UNITED STATES PATENT AND TRADEMARK OFFICE

APPLICATION NO.	FILING DATE	FIRST NAMED INVENTOR	ATTORNEY DOCKET NO.	CONFIRMATION NO.
09/929,488	08/15/2001	Kimikazu Matsumoto	250901/00	1362

**Office Action Summary**

## **DETAILED ACTION**

**FIG. 1A(PRIOR ART)**

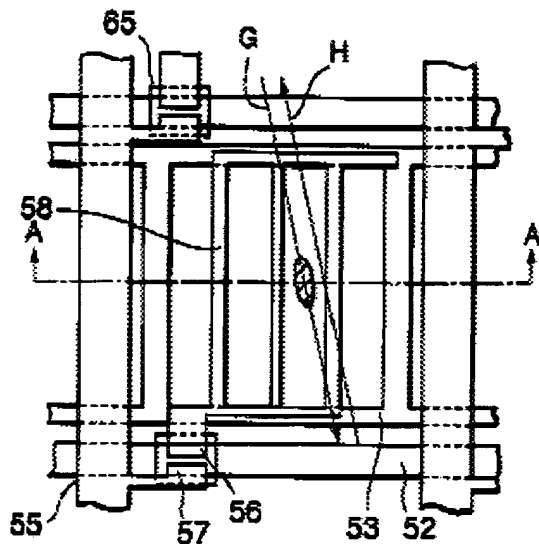
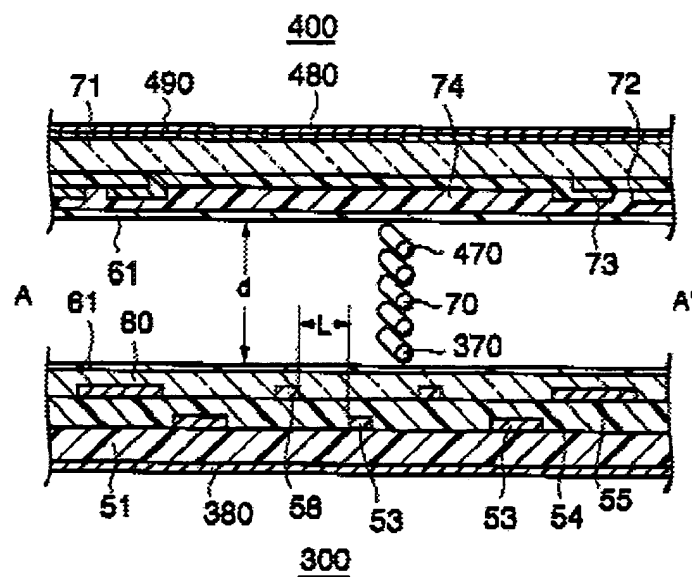
As to claims 8 and 9, Baur does not explicitly disclose a display wherein a gate wiring of a thin film transistor is formed on said first substrate simultaneously with said common wiring and wherein an island disposed above said common wiring and made of a semiconductor film is formed in said insulating film, and said island constitutes an active region of a thin film transistor. However, these are merely common knowledge means of comprising a satisfactory TFT display configuration.

Applicant's admitted prior art (APA) discloses these claimed features in Applicant's Figures 1A and 1B to comprise a satisfactory TFT display configuration.

APA is evidence that ordinary workers in the art of liquid crystals would find the reason, suggestion, or motivation to add a display wherein a gate wiring of a thin film transistor is formed on said first substrate simultaneously with said common wiring and wherein an island disposed above said common wiring and made of a semiconductor

film is formed in said insulating film, and said island constitutes an active region of a thin film transistor to comprise a satisfactory TFT display configuration.

Therefore, it would have been obvious to one having ordinary skill in the art of liquid crystals at the time the invention was made to modify the LCD of Baur with a display wherein a gate wiring of a thin film transistor is formed on said first substrate simultaneously with said common wiring and wherein an island disposed above said common wiring and made of a semiconductor film is formed in said insulating film, and said island constitutes an active region of a thin film transistor of APA to comprise a satisfactory TFT display configuration.

FIG. 2

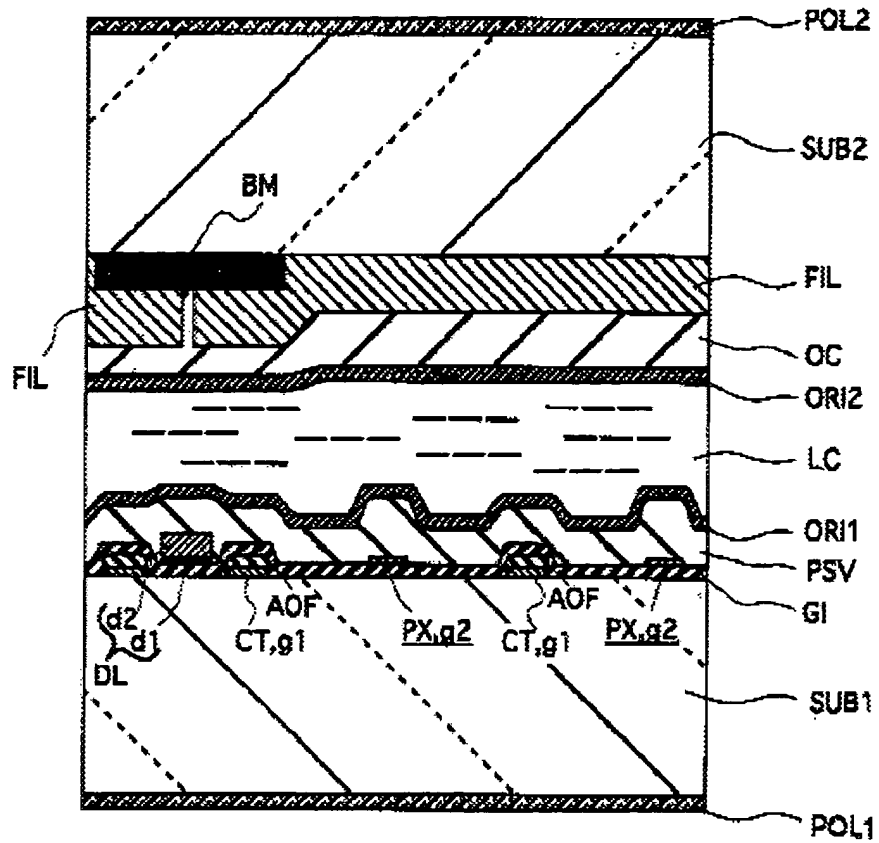
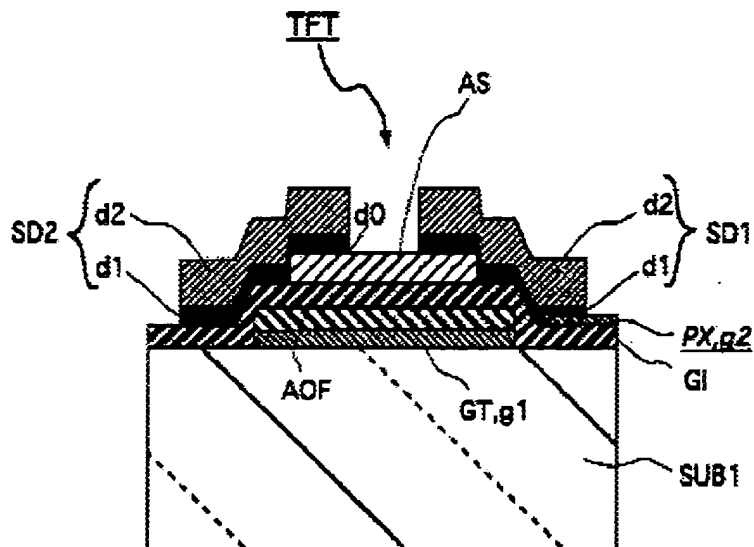
As to claims 8 and 9, Baur does not explicitly disclose a display wherein a gate wiring of a thin film transistor is formed on said first substrate simultaneously with said common wiring and wherein an island disposed above said common wiring and made of a semiconductor film is formed in said insulating film, and said island constitutes an active region of a thin film transistor. However, these are merely common knowledge means of comprising a satisfactory TFT display configuration.

Ohta discloses these claimed features in Figures 2 and 3 to comprise a satisfactory TFT display configuration with *inter alia* wide viewing angle (Abstract).

Ohta is evidence that ordinary workers in the art of liquid crystals would find the reason, suggestion, or motivation to add a display wherein a gate wiring of a thin film transistor is formed on said first substrate simultaneously with said common wiring and wherein an island disposed above said common wiring and made of a semiconductor film is formed in said insulating film, and said island constitutes an active region of a thin film transistor to comprise a satisfactory TFT display configuration with wide viewing angle.

Therefore, it would have been obvious to one having ordinary skill in the art of liquid crystals at the time the invention was made to modify the LCD of Baur with a display wherein a gate wiring of a thin film transistor is formed on said first substrate simultaneously with said common wiring and wherein an island disposed above said common wiring and made of a semiconductor film is formed in said insulating film, and

said island constitutes an active region of a thin film transistor of Ohta to comprise a satisfactory TFT display configuration with wide viewing angle.
